KLUM LAKE ACCESS  
ROAD MAINTENANCE  
LOUSIA COUNTY, IOWA  
PROJECT NUMBER: 20-06-58-01

February 12, 2021

This Addendum is issued to modify, explain or correct the original Drawings and Specifications, and is hereby made a part of the Contract Documents. Please attach this Addendum to the Project Manual in your possession. Insert the number and issue date of this Addendum in the blank space provided on the Proposal Form.

**D.02**

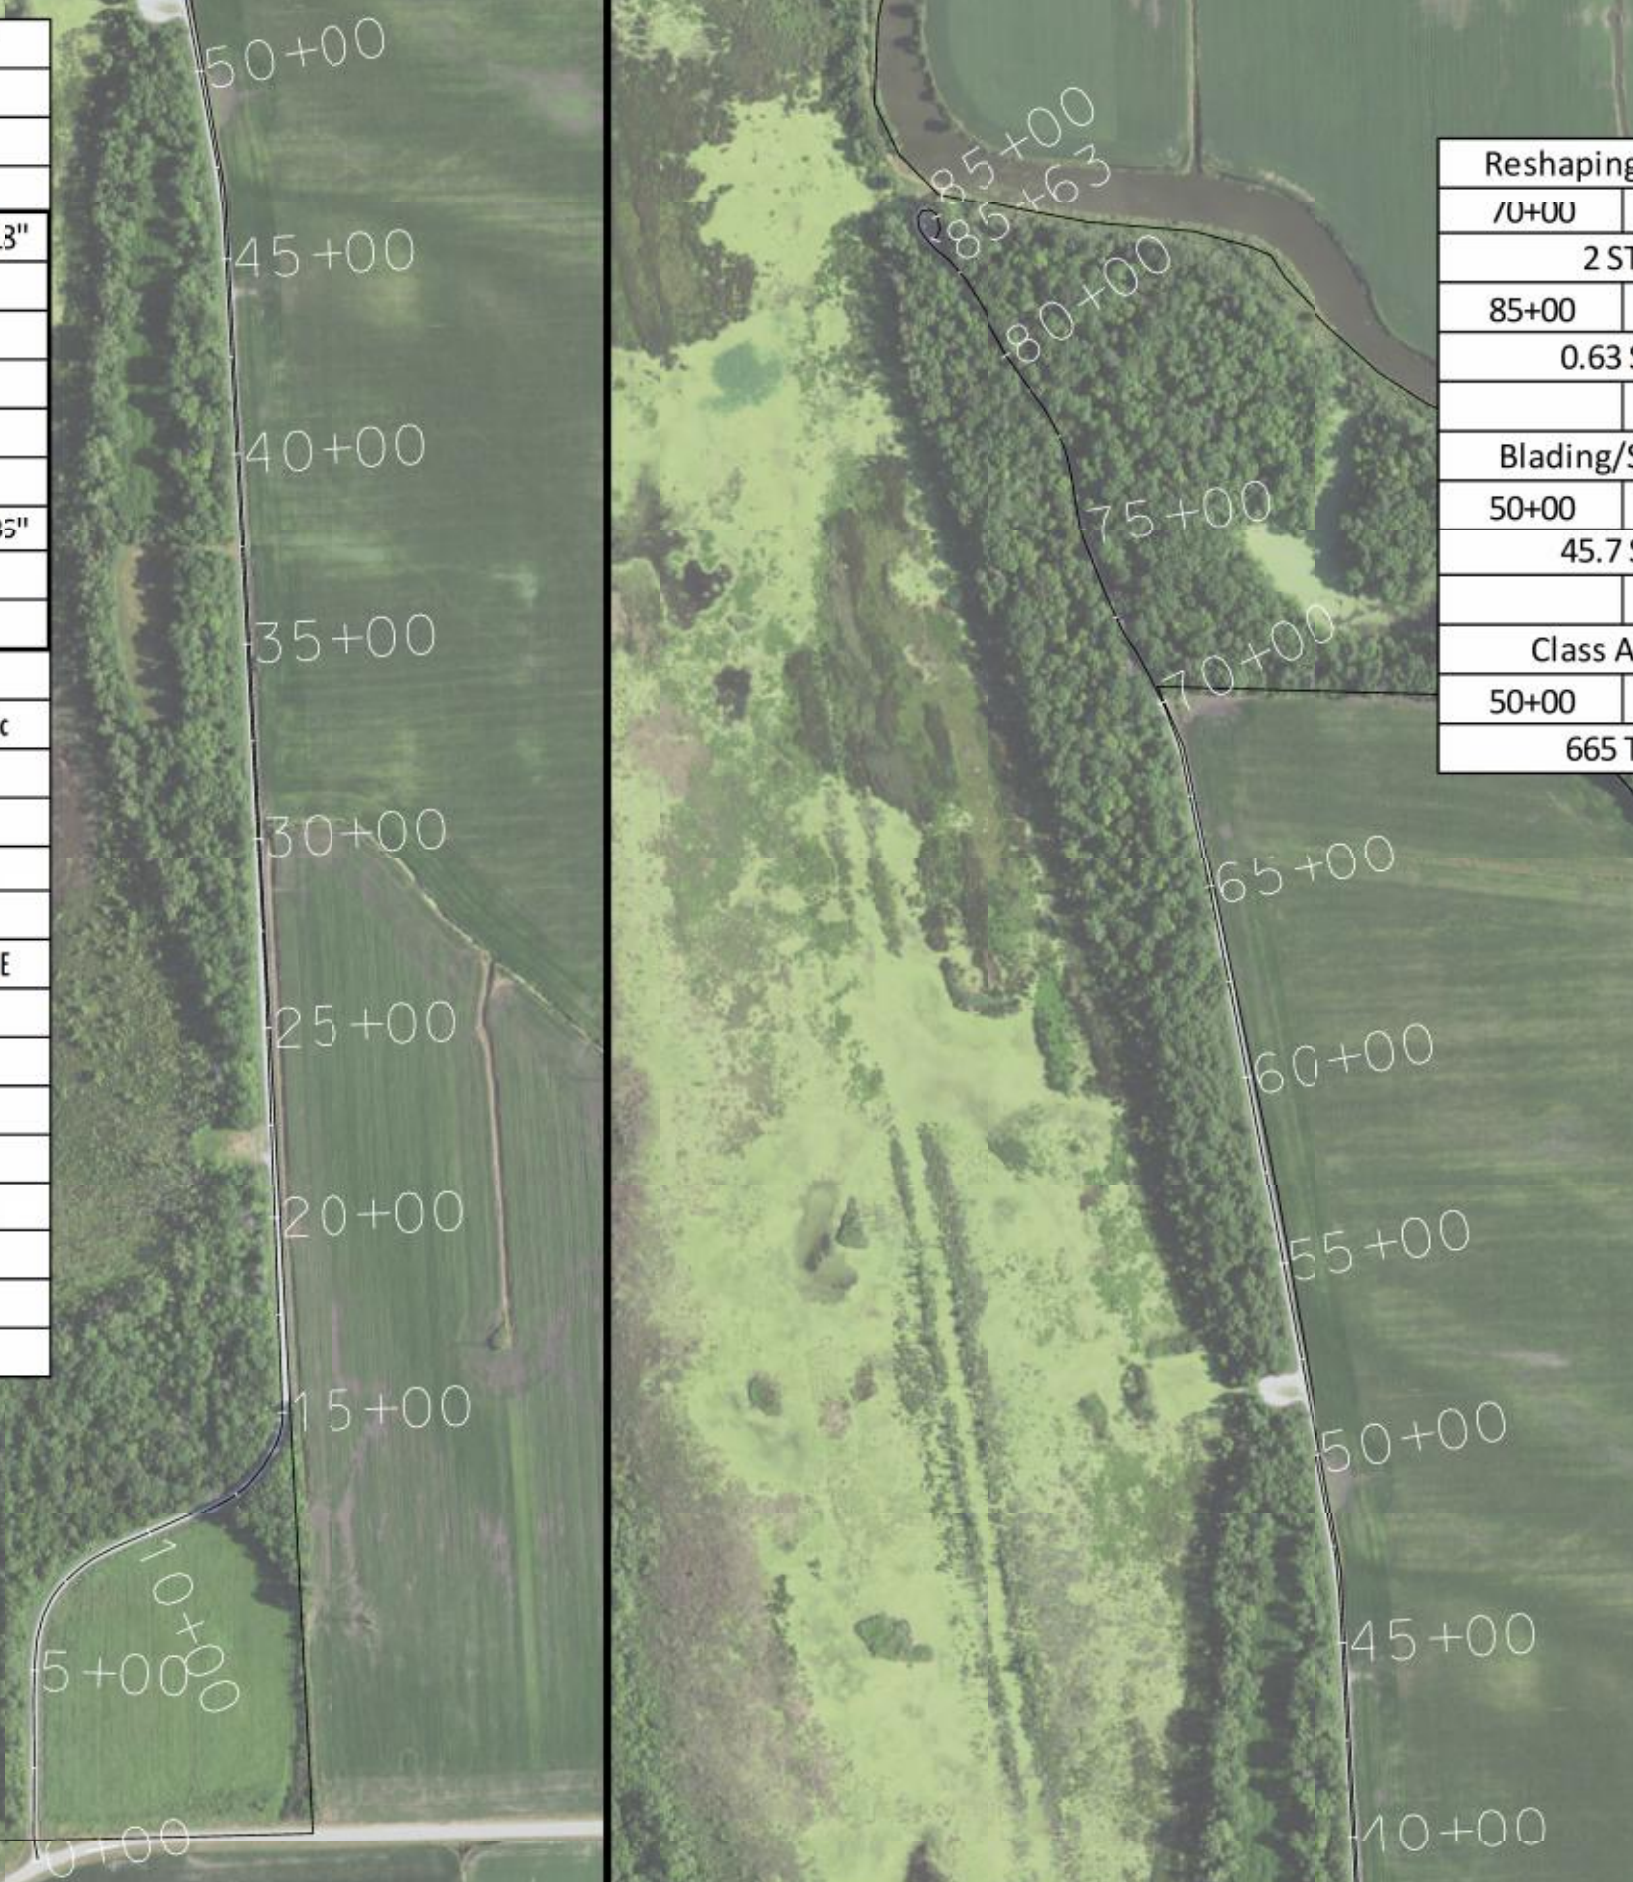
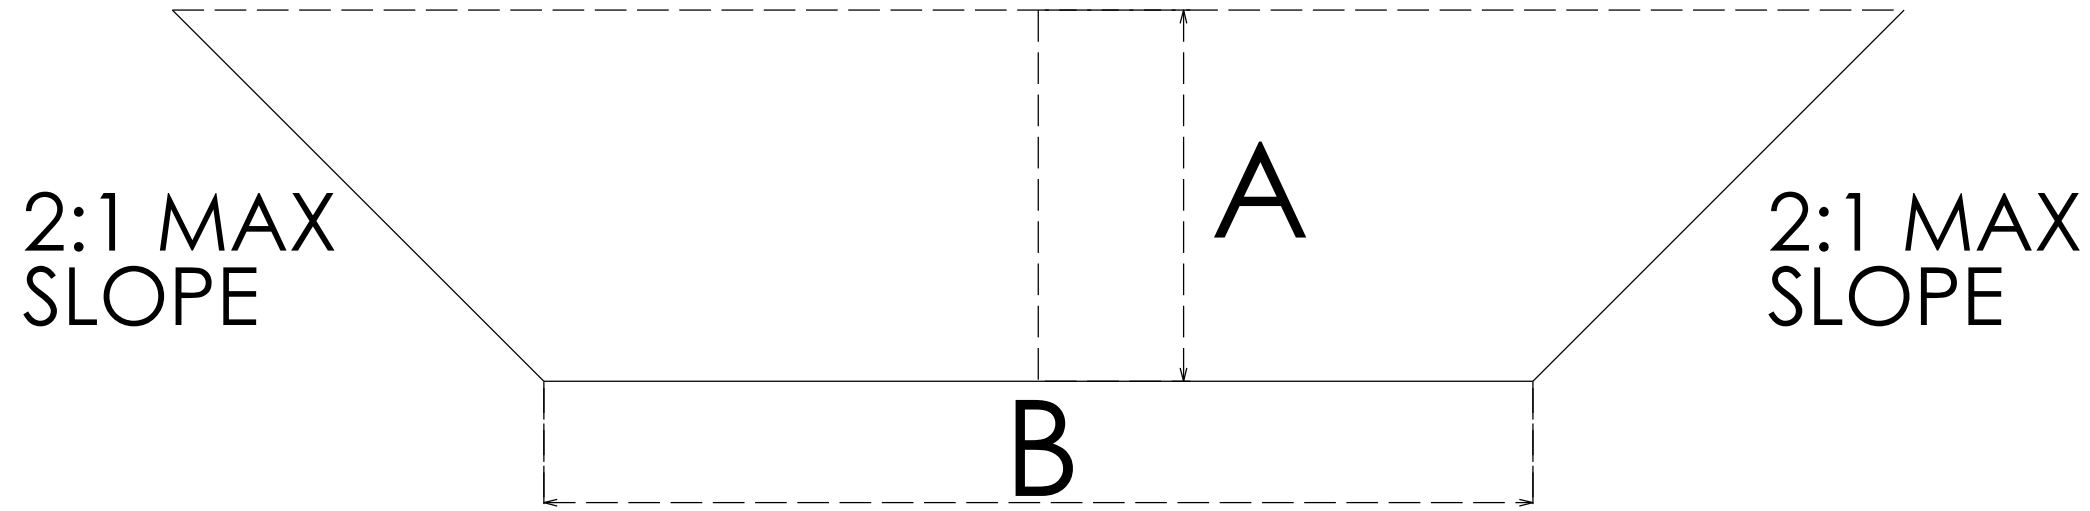
1. Sheet D.02

Add:

Special Backfill
(Pipe Bedding)
19+50
4.6 Ton
30+00
12.8 Ton
37+50
4.6 Ton

CONC RDWY PIPE, 18"
19+50
32 LF
37+50
32 LF
CONC RDWY PIPE, 36"
30+00
36 LF
